TO: Patrice Tanner, City Administrator, City of Chipley

FROM: Hadley Peterson, Community Planner

PROJECT: Chipley IPO 25-01 Development Review 03

Development Order Application

DATE: 1/19/26
 SCALE: 1"=20'
 SHEET
C3

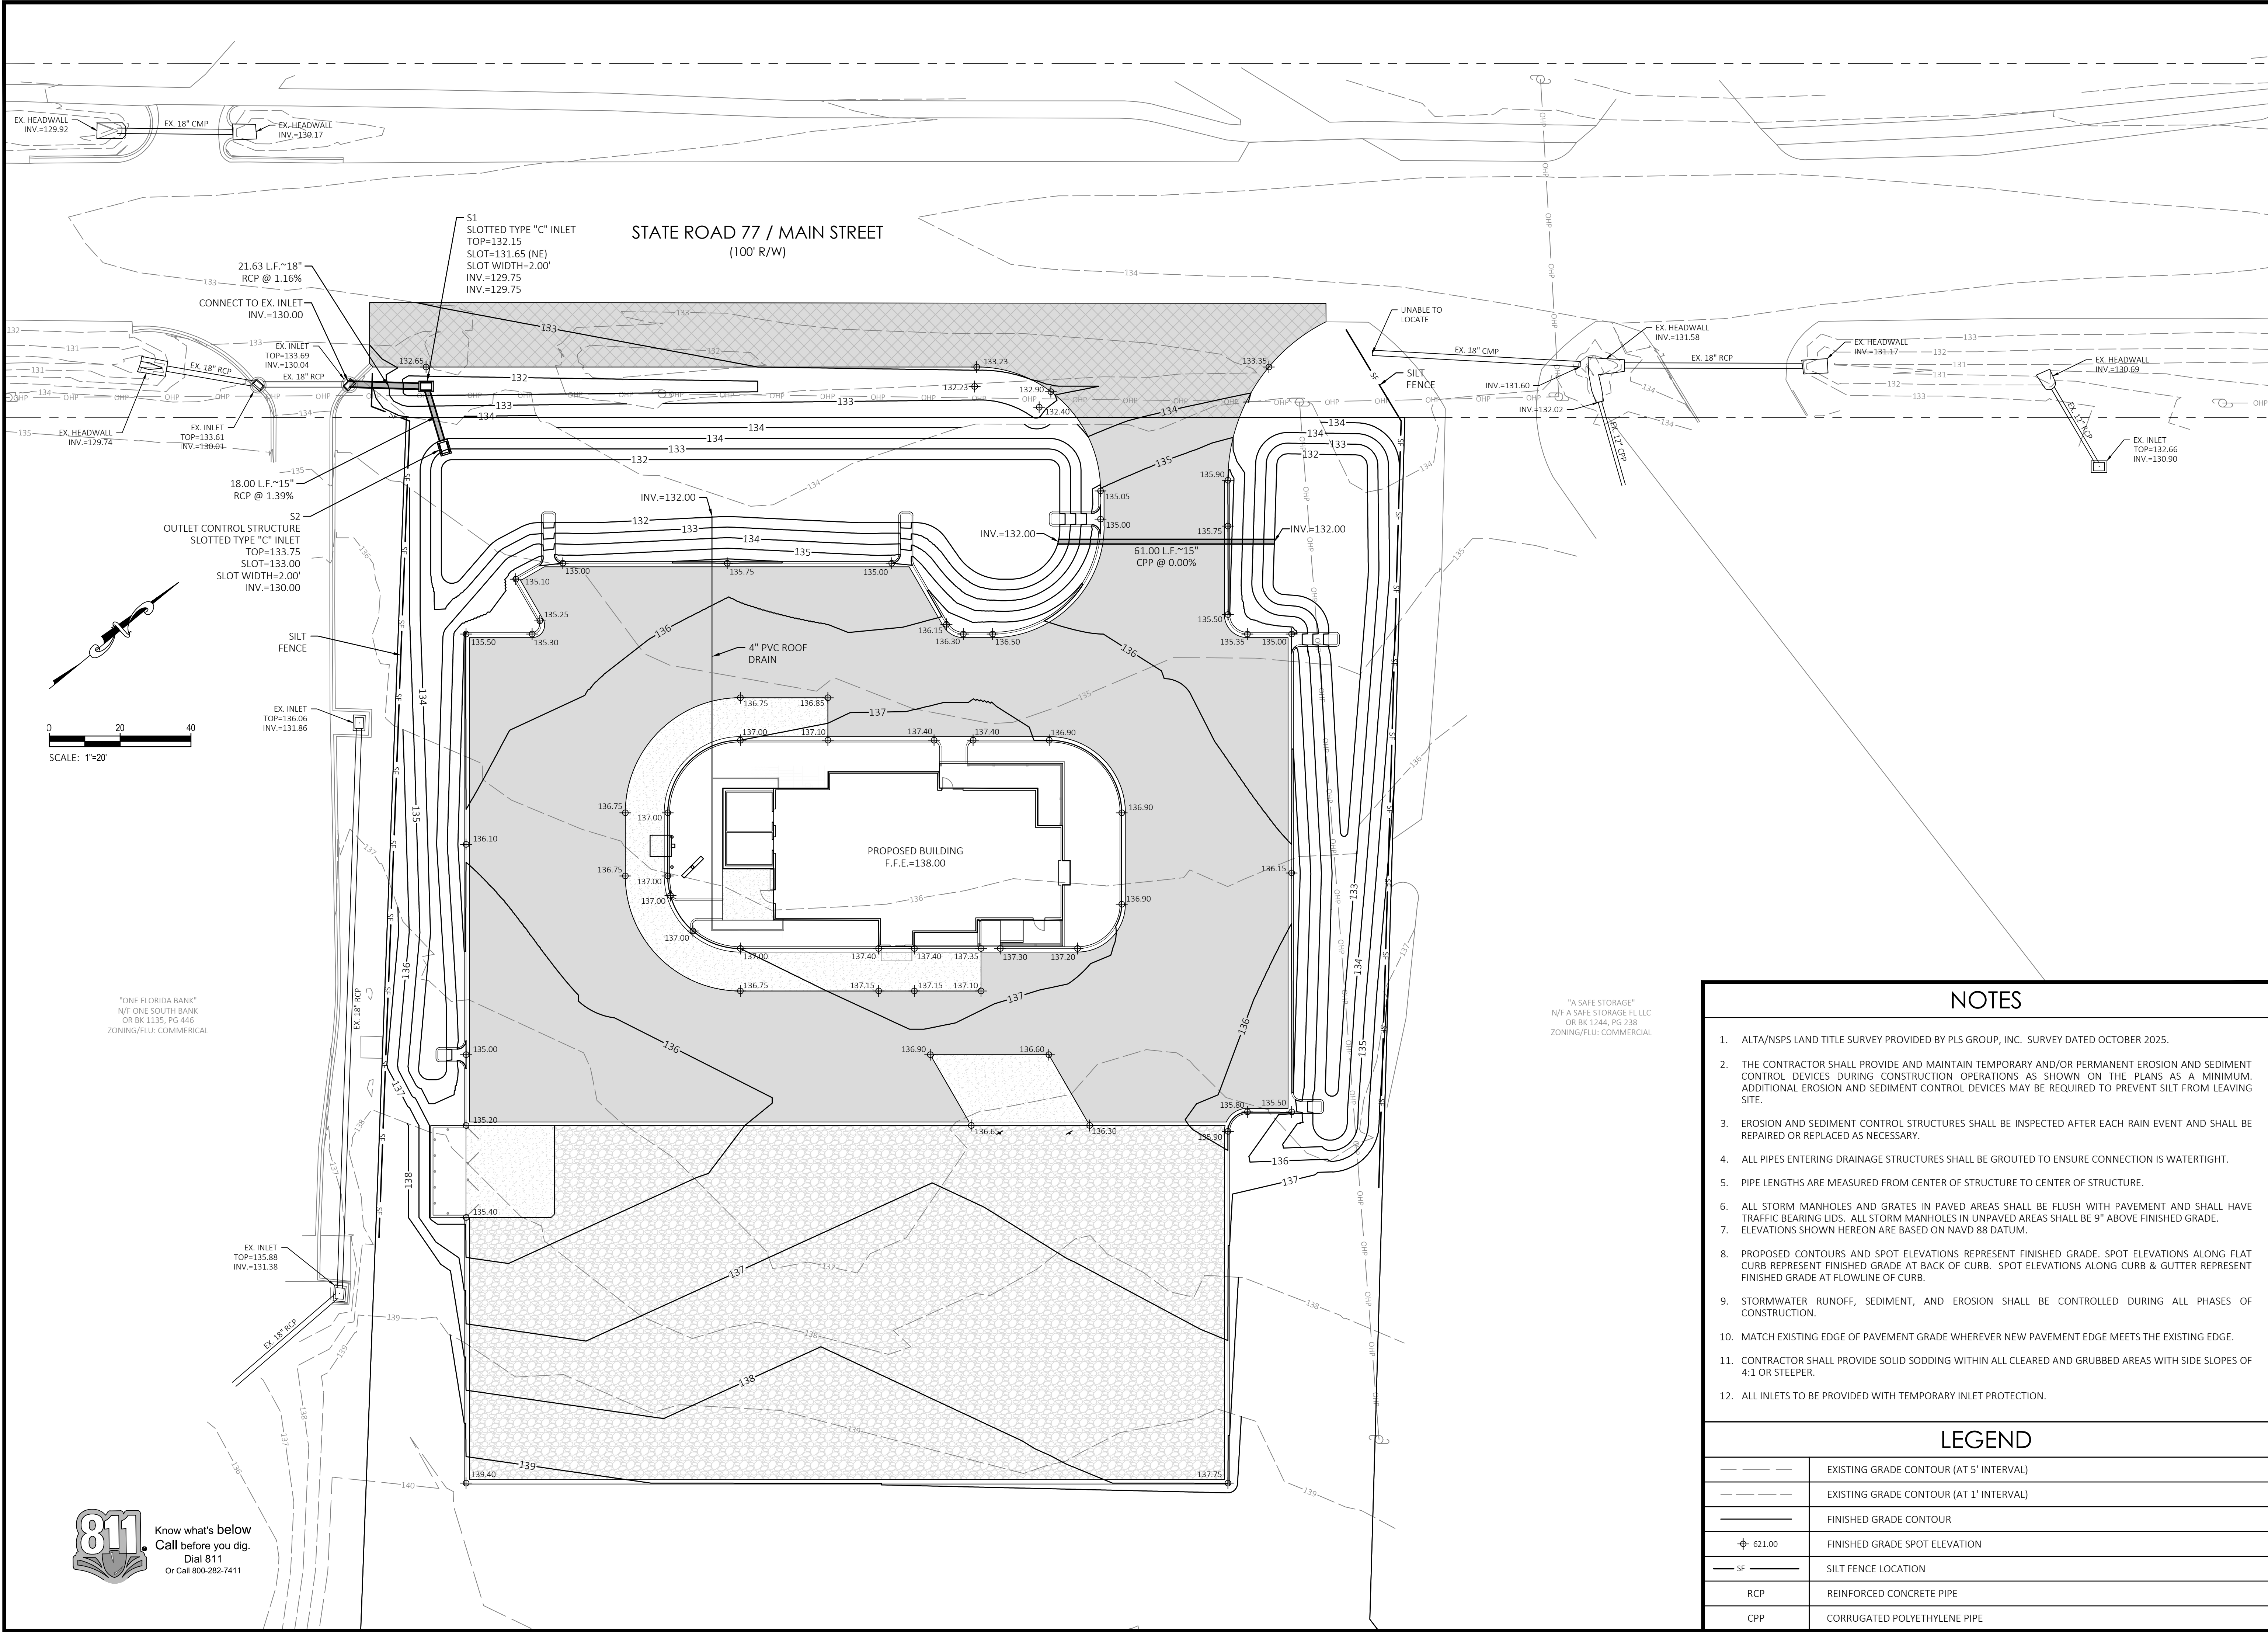
Sufficient: *Provided in Plan Set: Sheets C3, C7 & 01.*

JACK'S FAMILY RESTAURANT
 CHIPLEY, FLORIDA
UTILITY PLAN

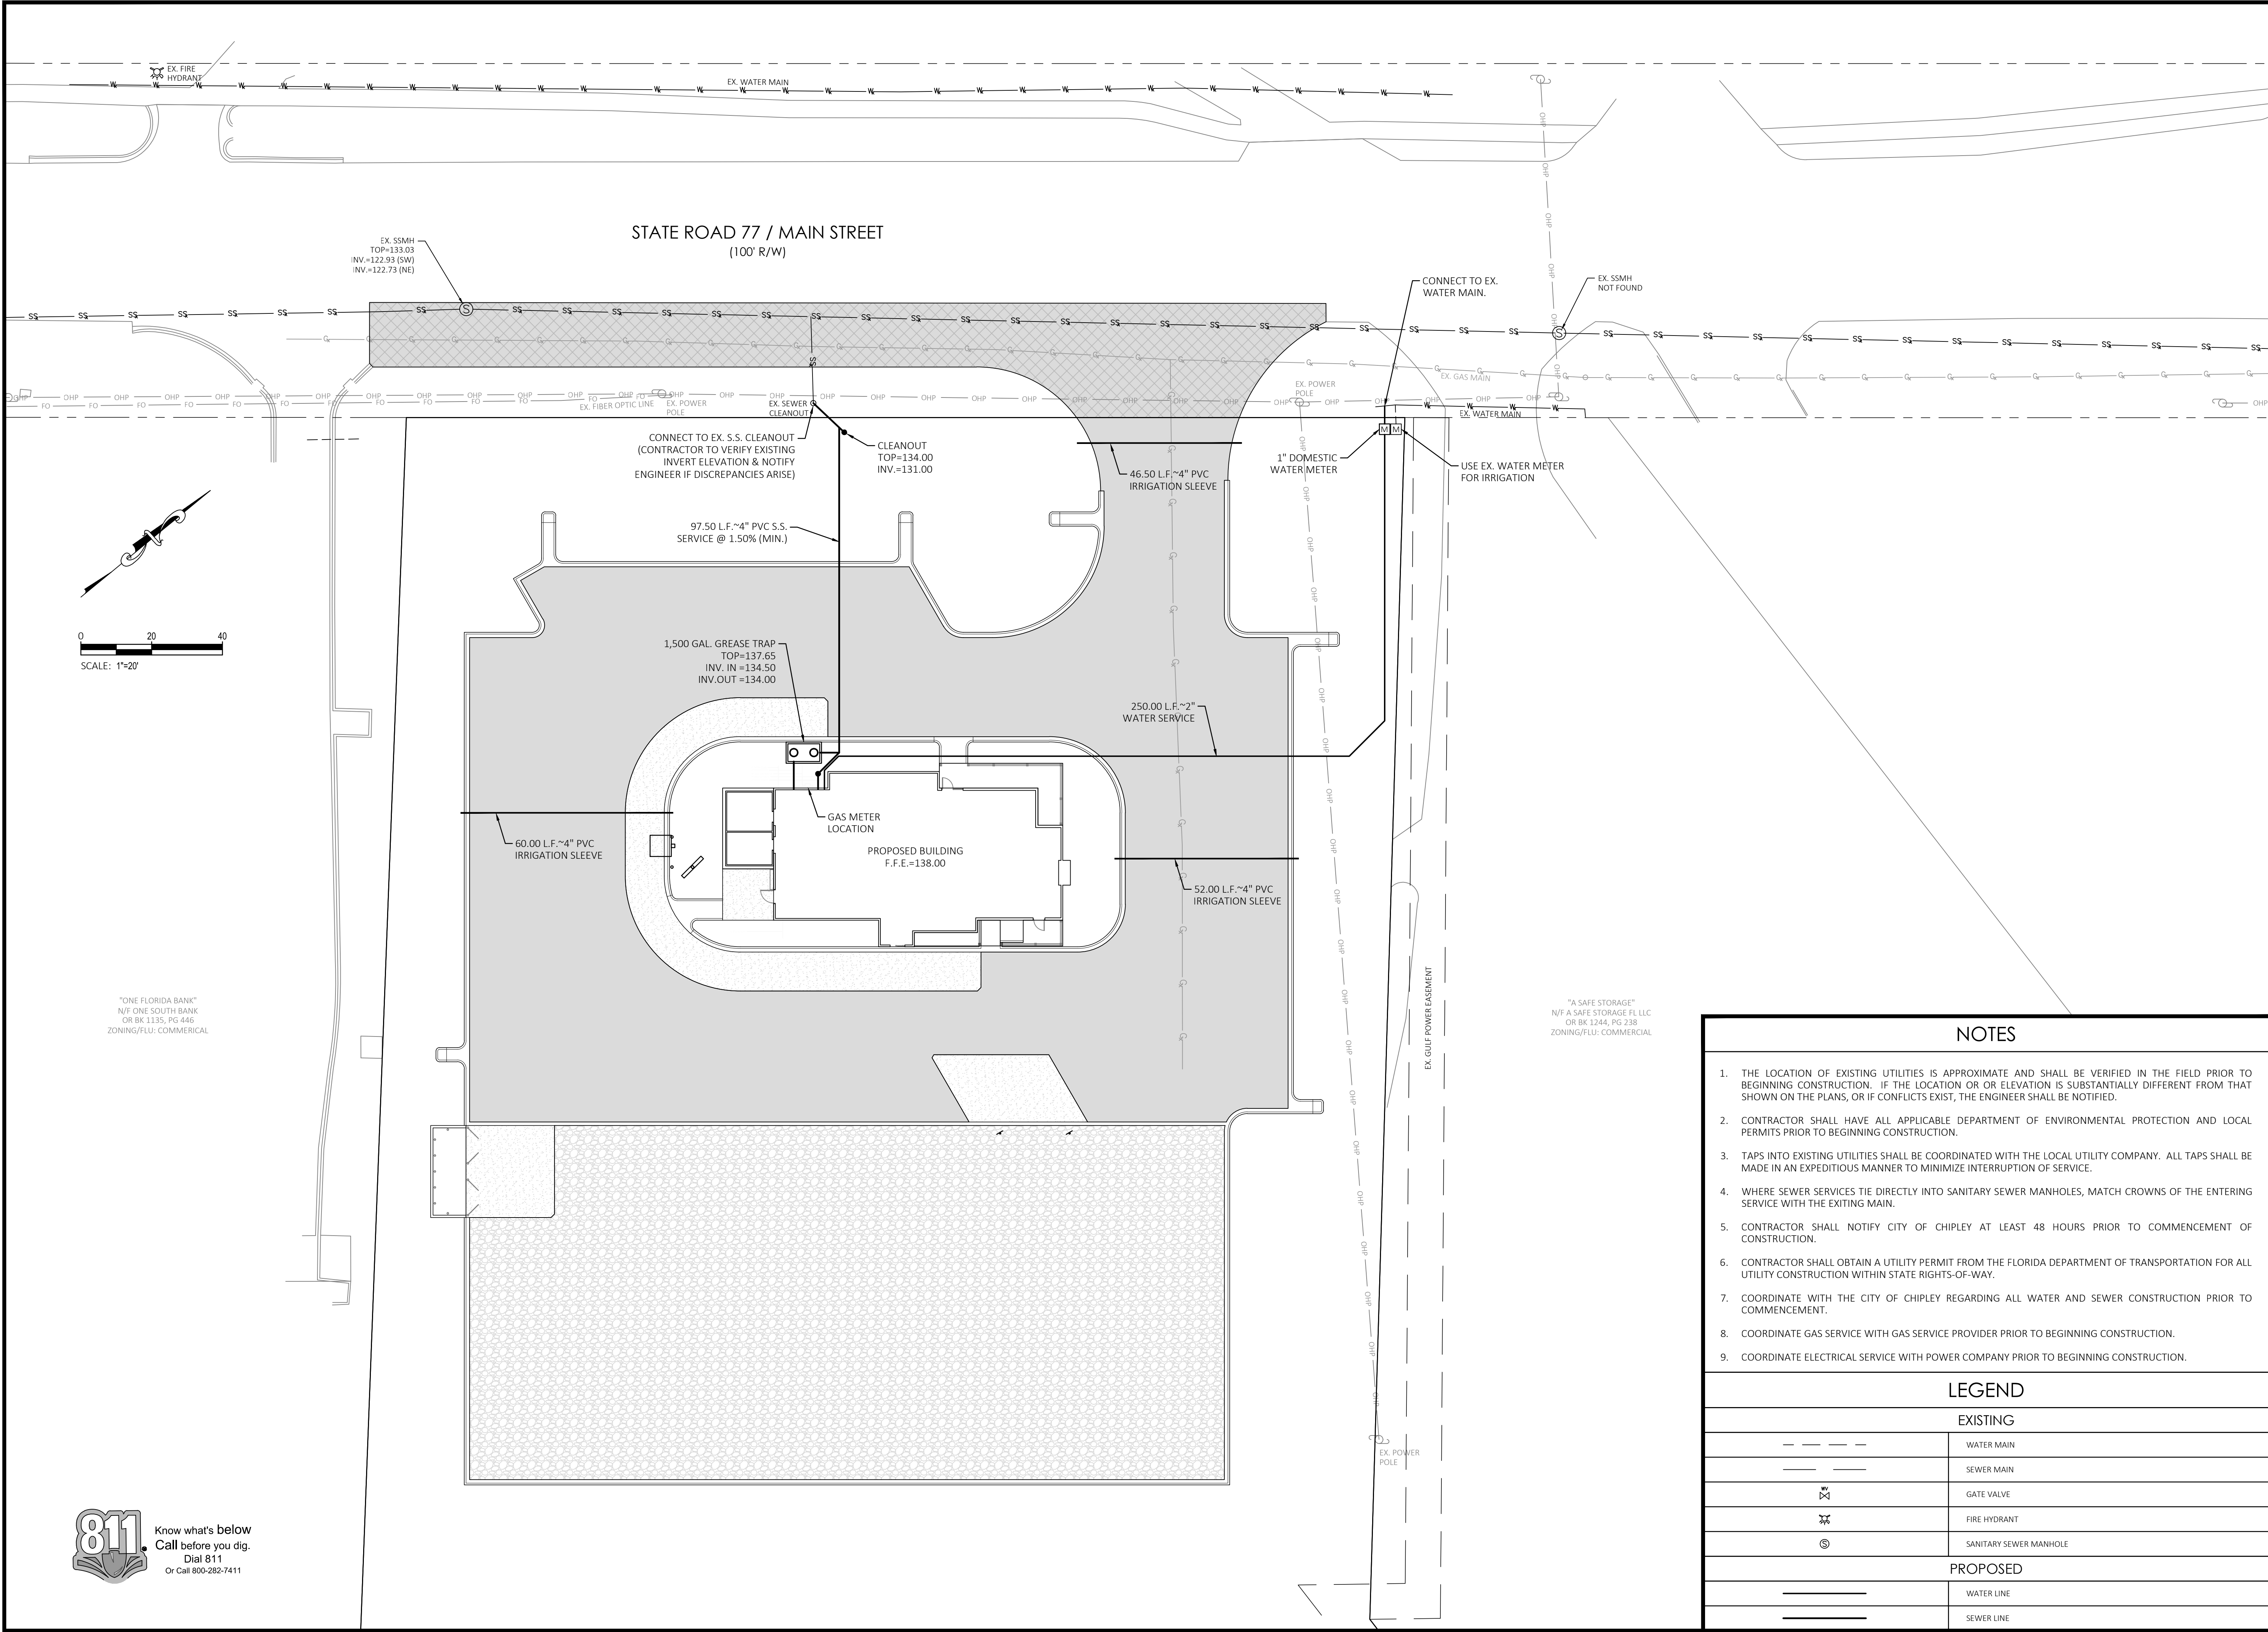
Sufficient: *Provided in Plan Set: Sheet C4.*
